ADDENDUM NUMBER 1

EVENT CENTER PARKING LOT EXPANSION @ VICTOR VALLEY COLLEGE

VICTOR VALLEY COMMUNITY COLLEGE DISTRICT

September 8, 2025

C-4.1

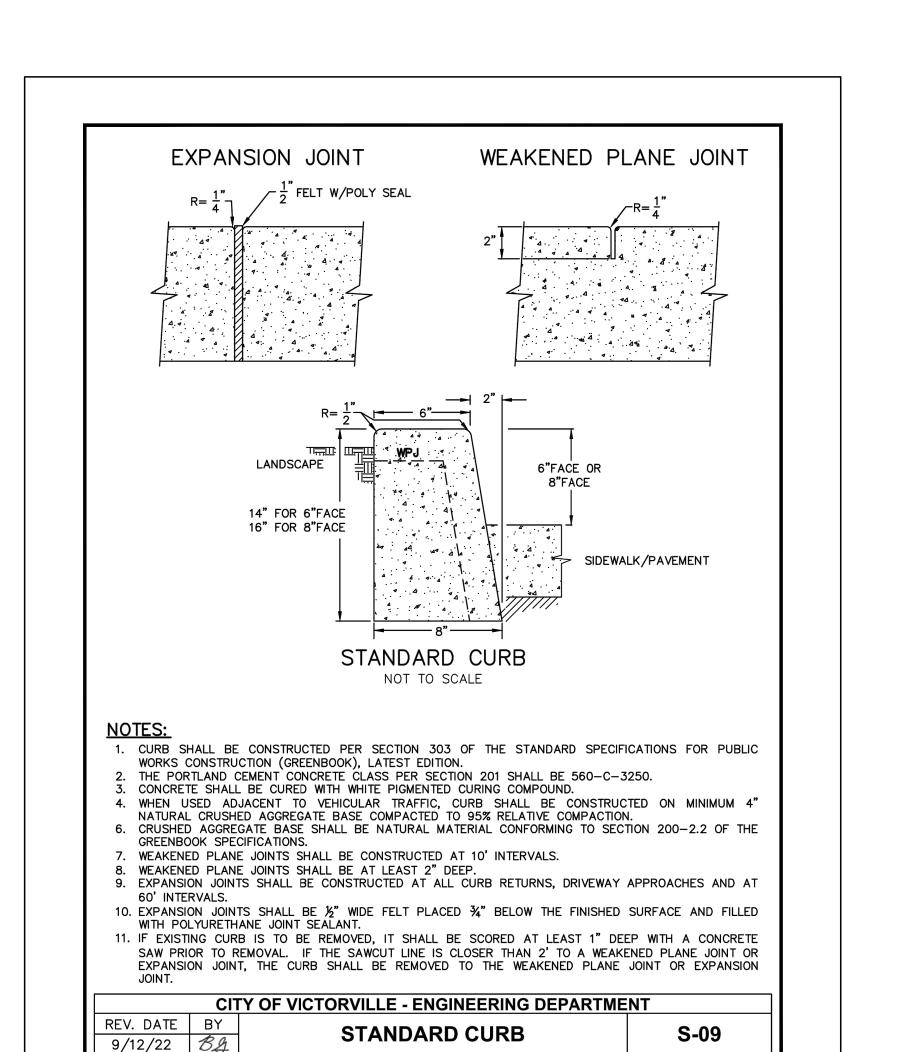
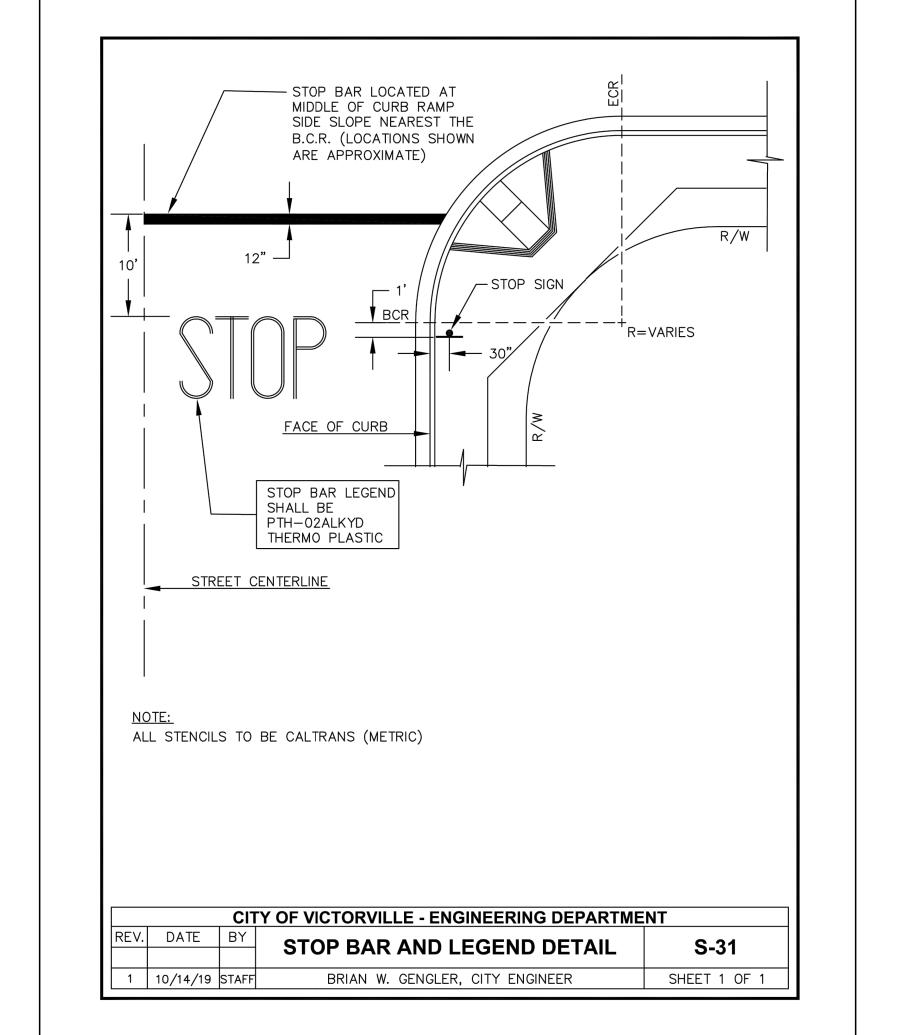
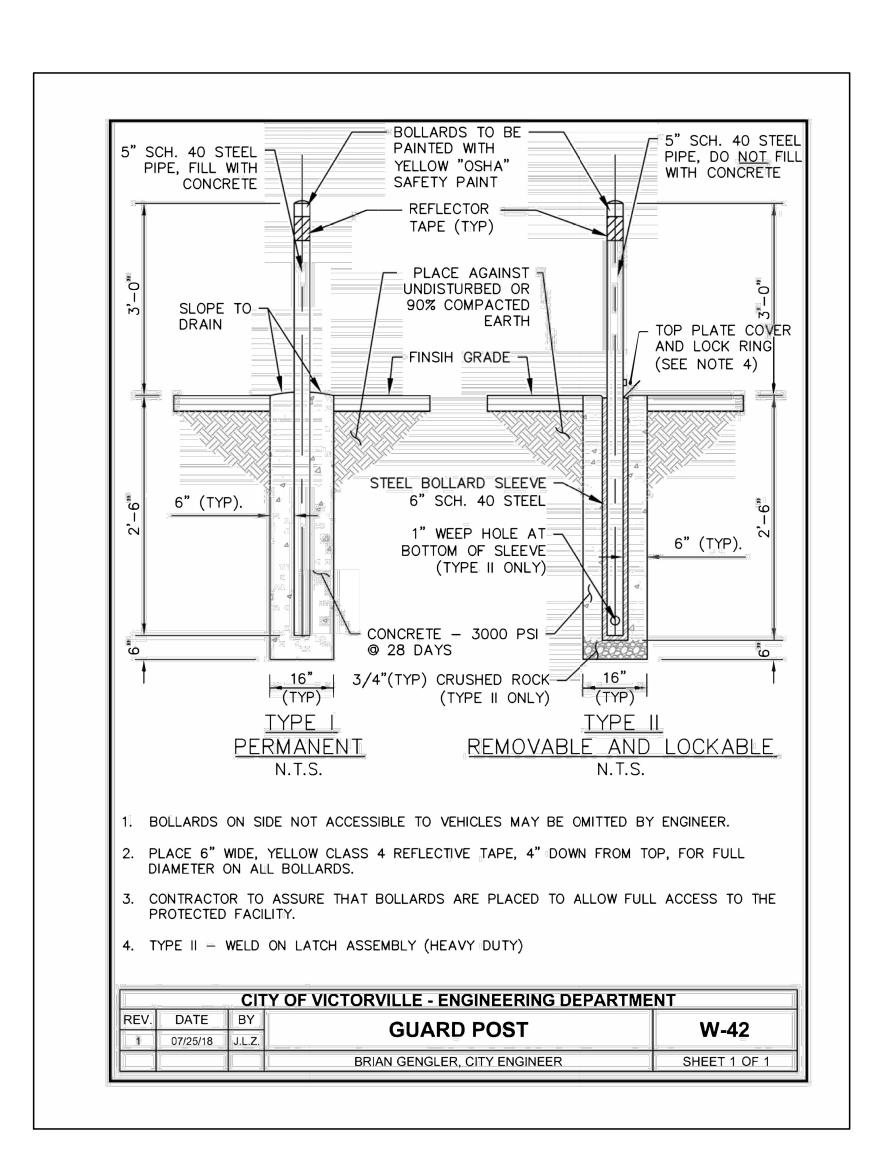
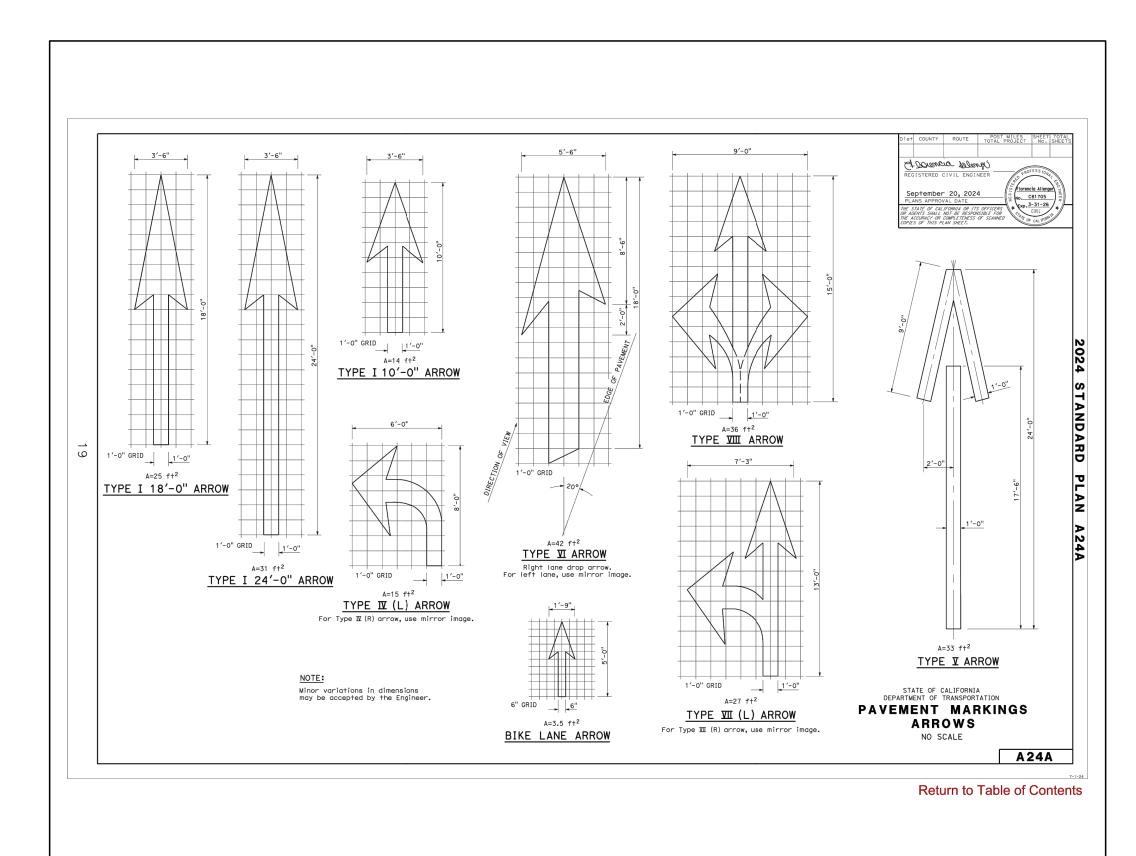
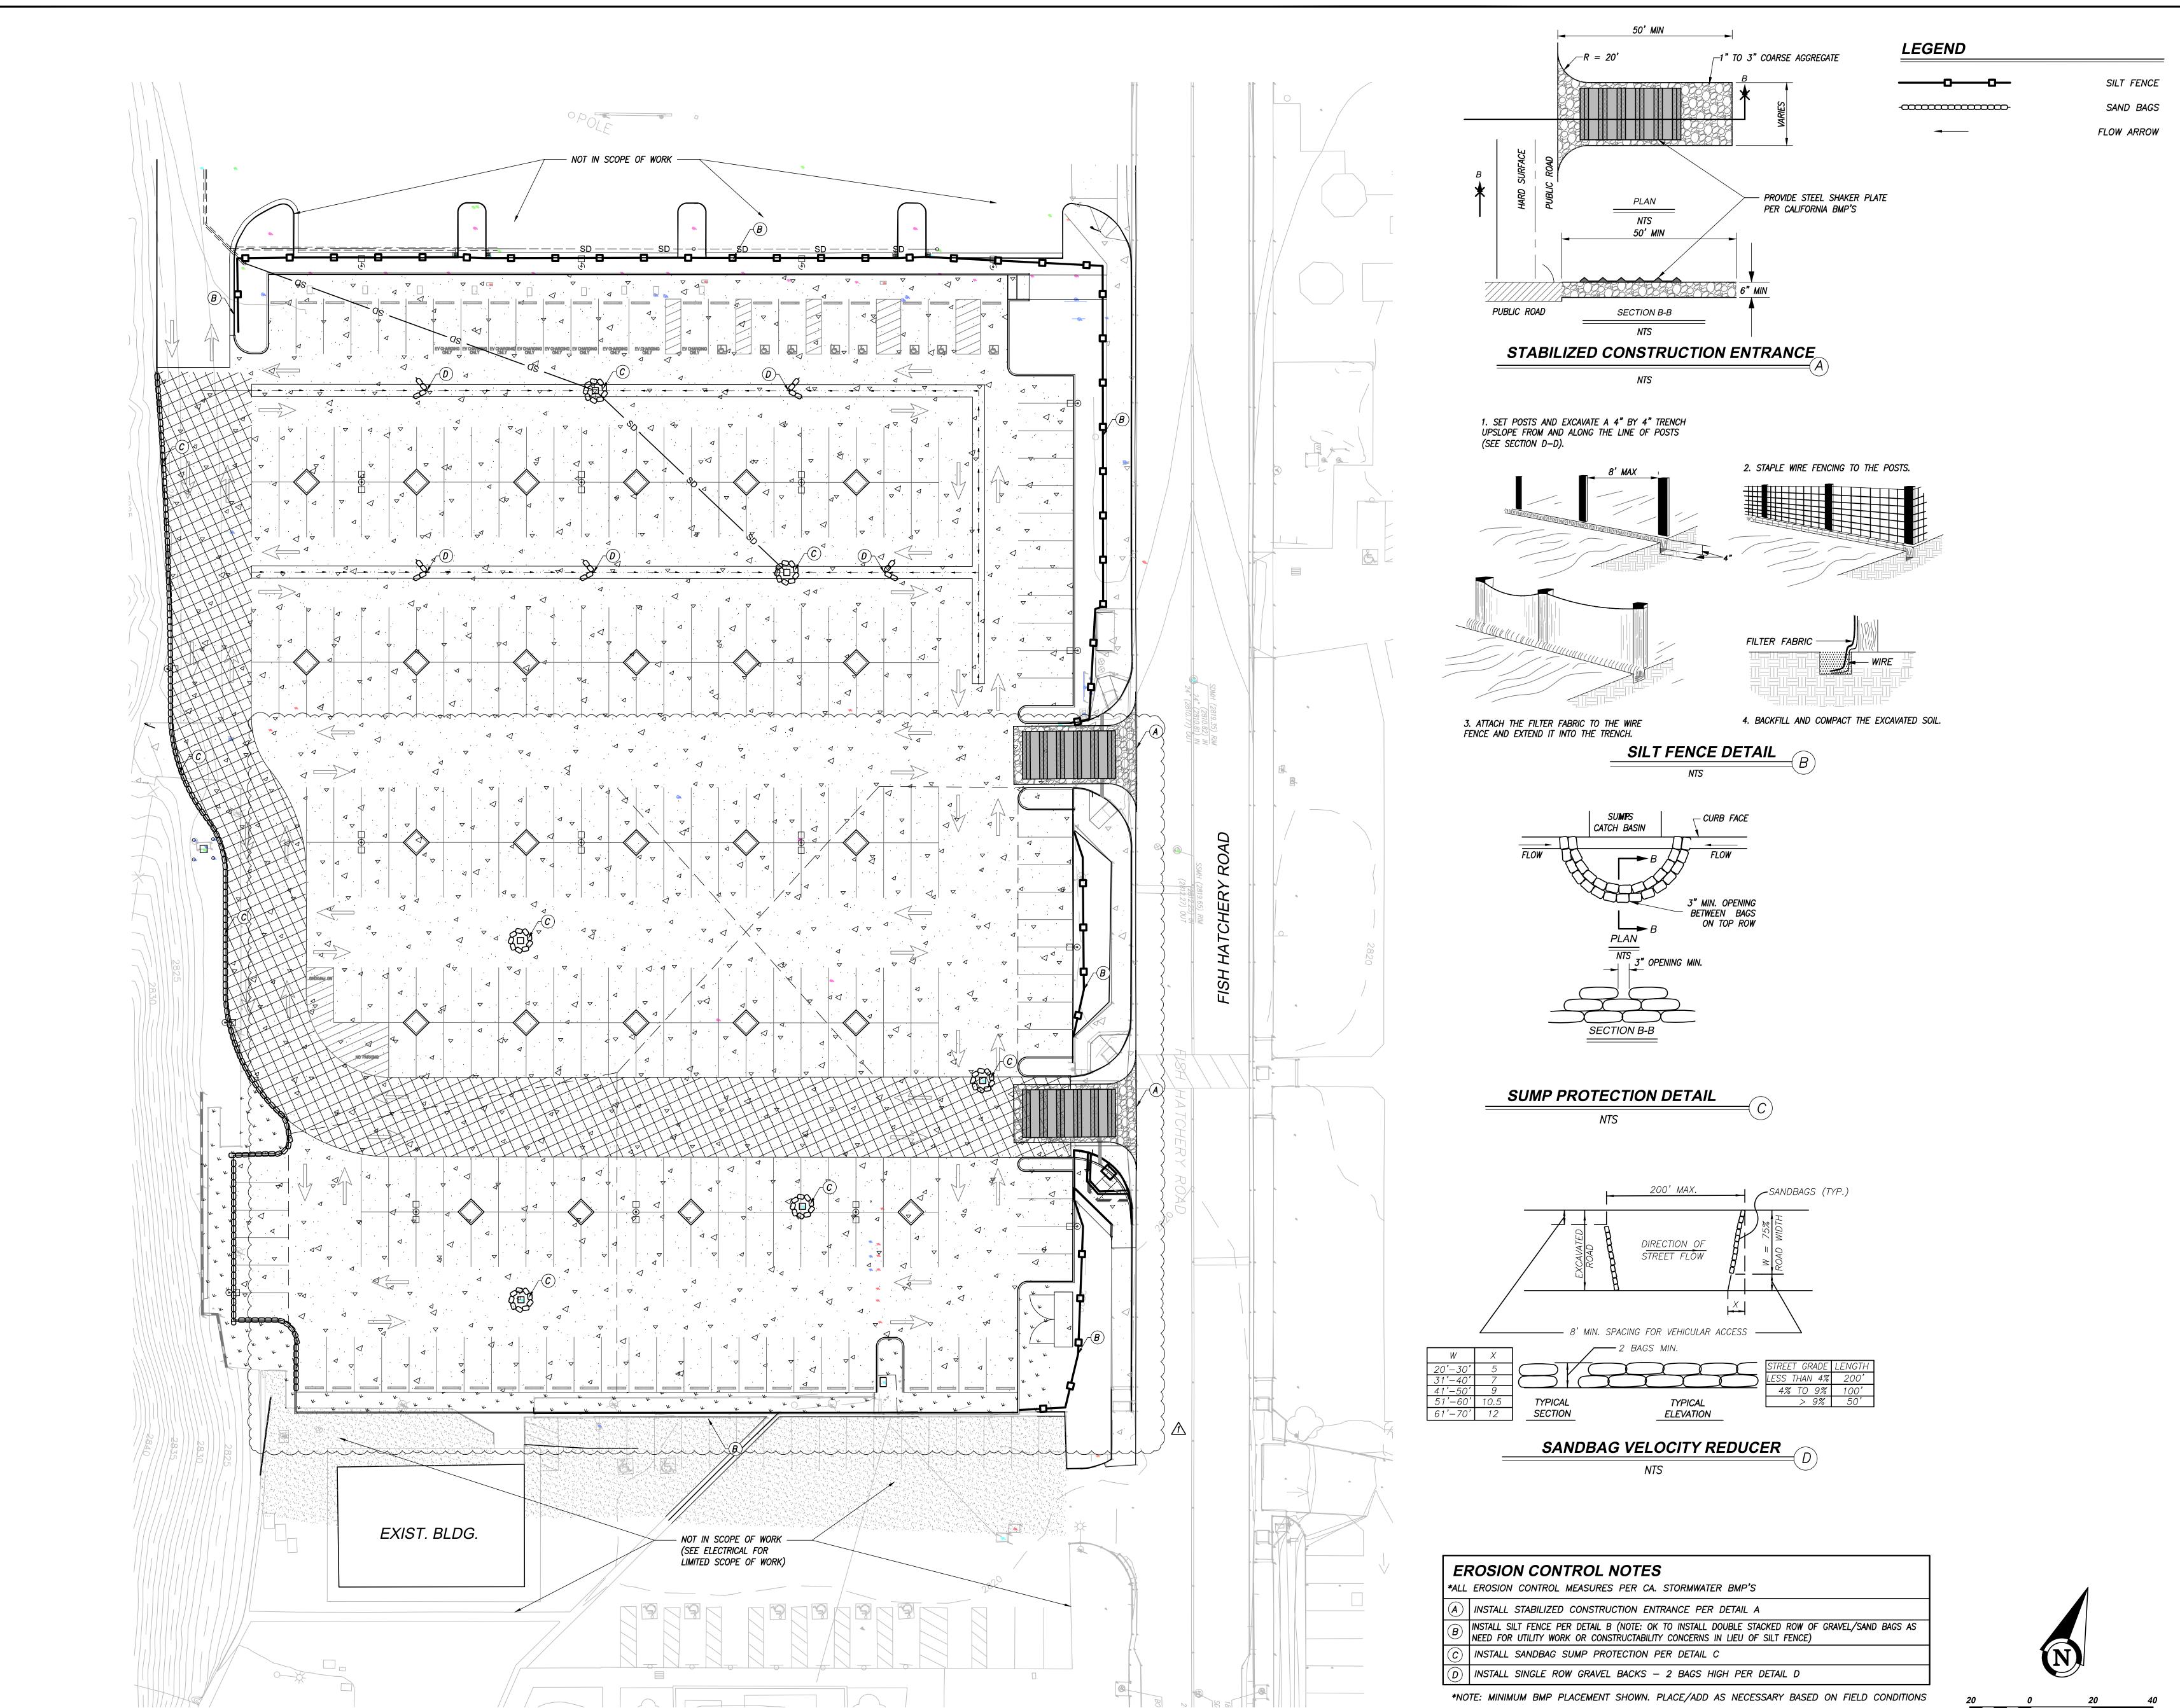
Item Number 7: Remove sheet C-4.1 - Sections & Details and replace with attached sheet C-4.1, clouded with delta-1. The following changes were made:

- A. Shifted C.N.s #6, 7, and 8 down once respectively. In other words, C.N. #5, 6, 7, and 8 are now #4, 5, 6, and 7.
- B. Revised details accordingly.

EROSION CONTROL PLAN

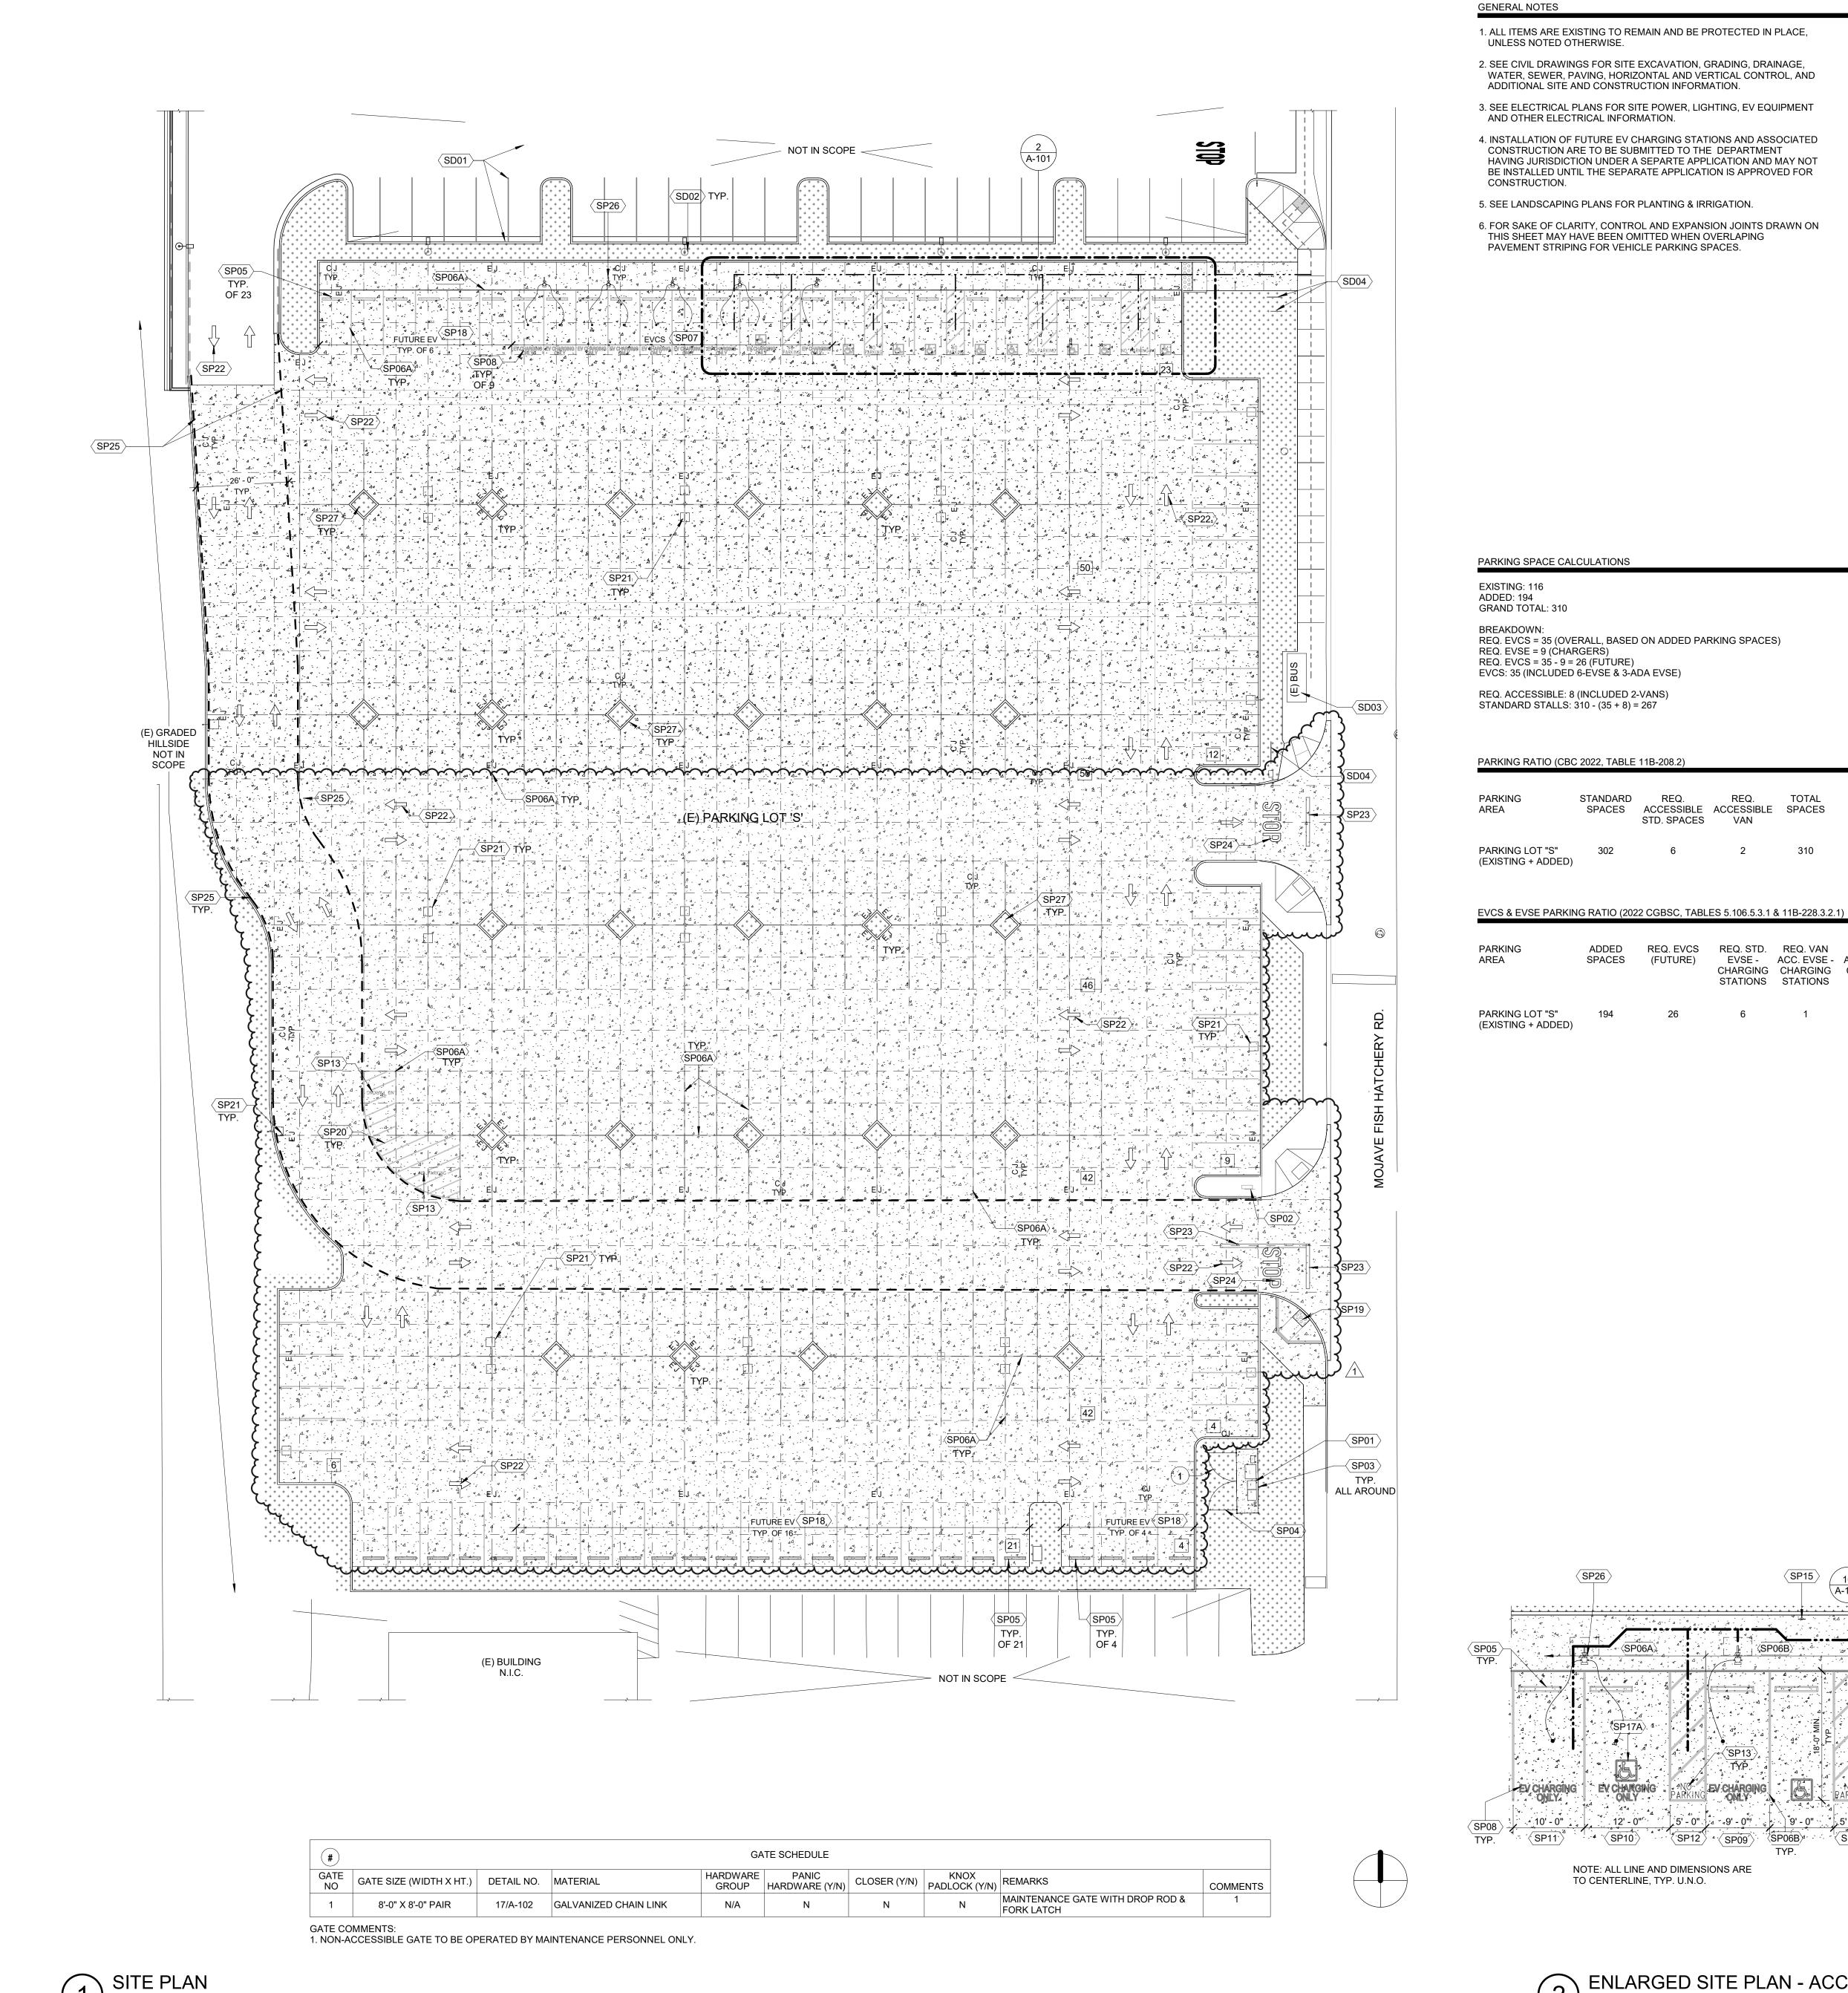
Item Number 8: Remove sheet C-5.0 - Erosion Control Plan and replace with attached sheet C-5.0, clouded with delta-1. The following changes were made:

A. Revised hatching to depict new limits of proposed PCC paving accordingly.
